2. Description of the project

2.1 Summary of comments

A summary of the comments received during the JRYUP EIS consultation process in relation to the description of the project are outlined below.

The following flow diagram details the proposed “operational” pollution treatment plant.

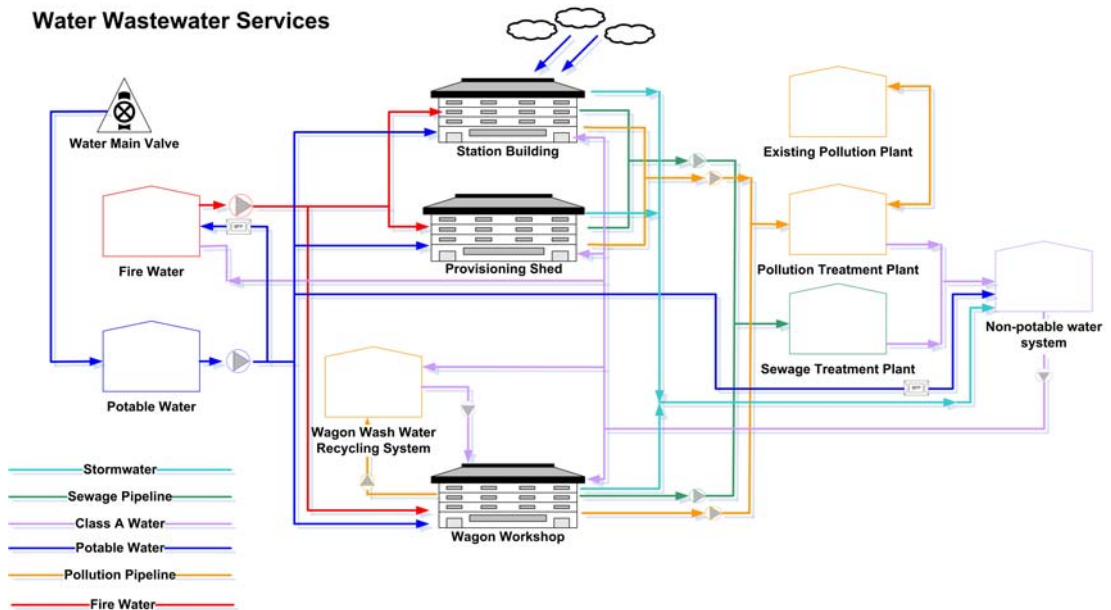
- More detailed identification of the quantity of new railway crossings, their location and design for Elizabeth and Willy Creeks.
- Specific details on the method of clearing.
- Clarifying the chosen option to move large volumes of fill from north of Elizabeth Creek to south of Willy Creek.
- Volumes of water to be used for the JRYUP to be specified.
- Identifying the options available to minimise the clearing of riparian vegetation and minimise disruption to the creek channel.
- Stormwater management system required.
- Identifying the chosen location for the JRYUP to traverse Elizabeth Creek with detailed maps/diagrams showing the position of bridges, vegetation to be cleared and revegetation areas involved.
- Further details on proposed operation of Pollution Treatment Plant.

A proposed pollution treatment plant will be designed and operated in conjunction with the existing pollution treatment system. Both plants will be connected by a rising main to provide a level of redundancy in the event of plant failure. Wastewater treated in the proposed pollution plant will be to Class-A+ standard, suitable for reuse as process wash water, toilet flushing and irrigation.

- Wagon maintenance facility
- Wagon wash bays (wagon wash water will be recycled via a dedicated water recycling system (closed system). Overflows from this system will be directed to the proposed pollution treatment plant)
- Provisioning shed
- Existing pollution treatment plant if the existing plant is out of service

The plant specification will be based on the existing pollution treatment plant influent, which is typically high in suspended solids, copper and hydrocarbons (including oil and grease). Table 2.5 outlines the design criteria for the proposed pollution treatment plant.
